To: T10 Technical Committee  
From: Rob Elliott, HP (elliott@hp.com) and Jay Neer, Molex (jay.neer@molex.com).  
Date: 29 April 2007  
Subject: 07-209r0 SAS-2 Mini SAS 4x cable plug pull tab color

**Suggested changes**

**[Figure 75 — Mini SAS 4x cable plug connector \[new\]](#)**

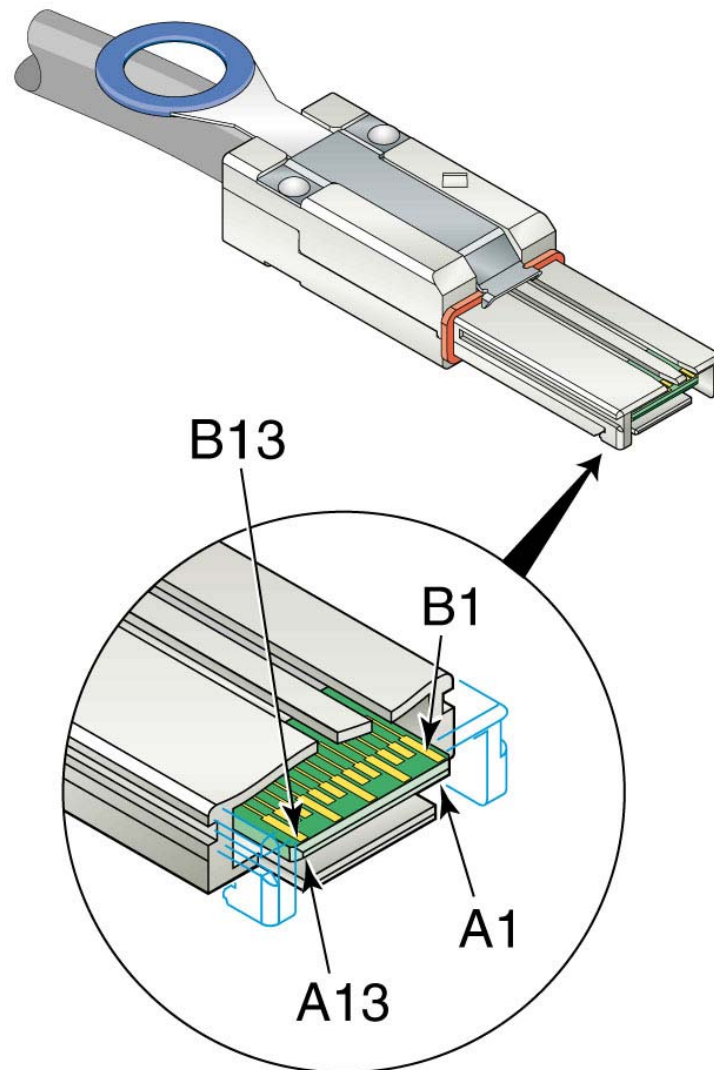
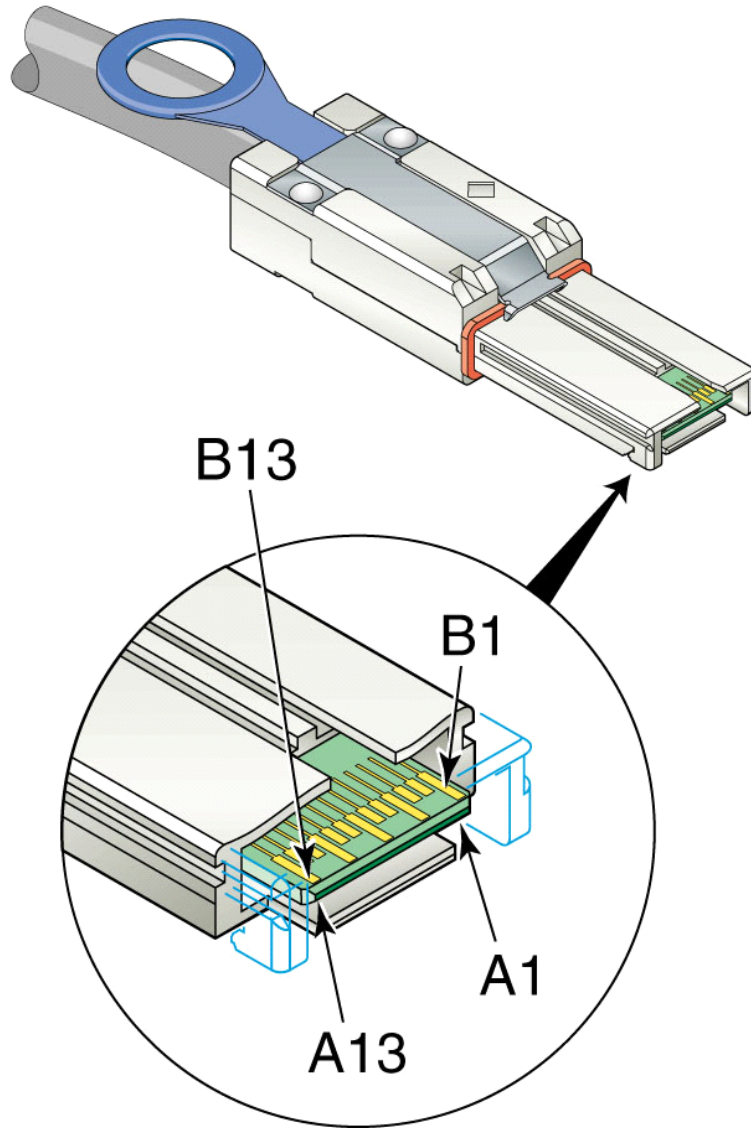
Mini SAS 4x cable plug connectors using pull-tabs (as shown in the figures) use a color matching PANTONE 279C (i.e., light blue) to differentiate them from other uses of similar connectors like PCI Express. The color should be mentioned by SAS-2.

Also, the first figure does not show color on the tab portion like the others. An updated figure from Cleaver Brinkerhoff (courtesy of Molex) is provided.

[If constructed with a pull tab as shown in figure 75, the pull tab should use PANTONE 279 C \(i.e., light blue coated\).](#)
